Subject	▶ Addition of Adhesive and Modification of Gear Housing Cover Complete
For Models	▶ HP2050, HP2050F, HP2051, HP2051F
Country	▶ All countries
Description	▶ See below.

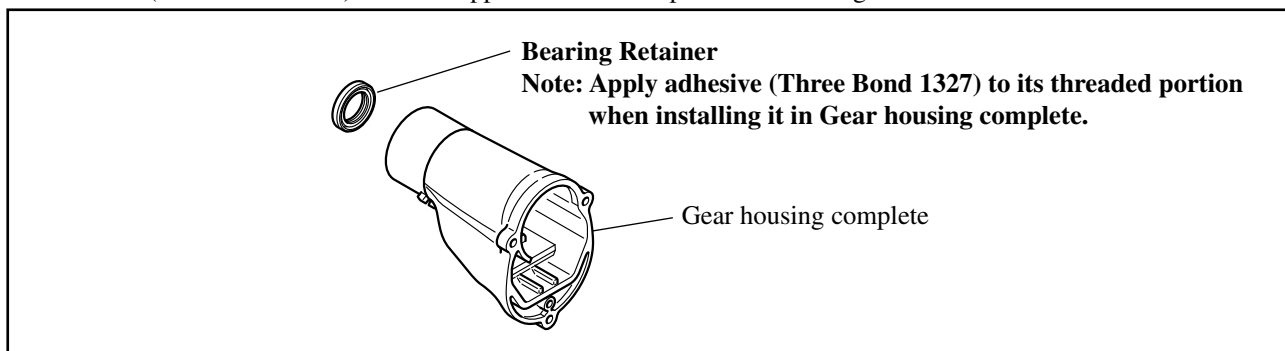
2. Shape of Gear housing cover complete has been modified as shown below.

▶ Current	▶ New
	 This portion of Gear housing cover complete has been cut off for distinction.
